Product Change Notification: PCN-23-172183

2822541-1 micro sim connector push push dip type

# SIM card PN 2822541-1 Date Code change because of shell plating supplier change

# SIM card PN 2822541-1 Date Code change point on shell

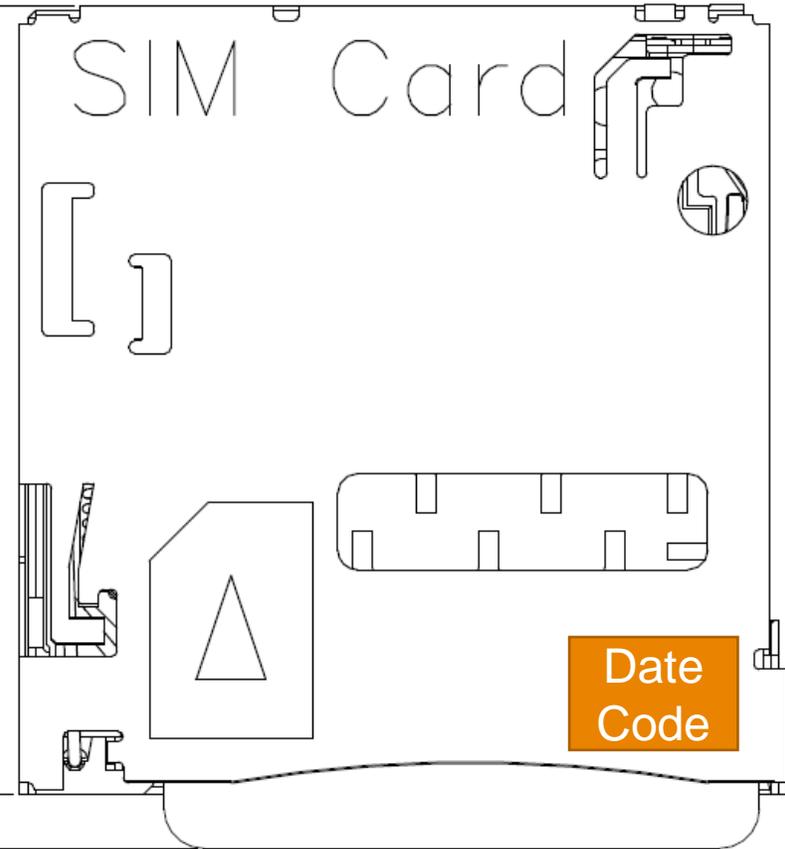
Current plating Date Code

new plating Date Code
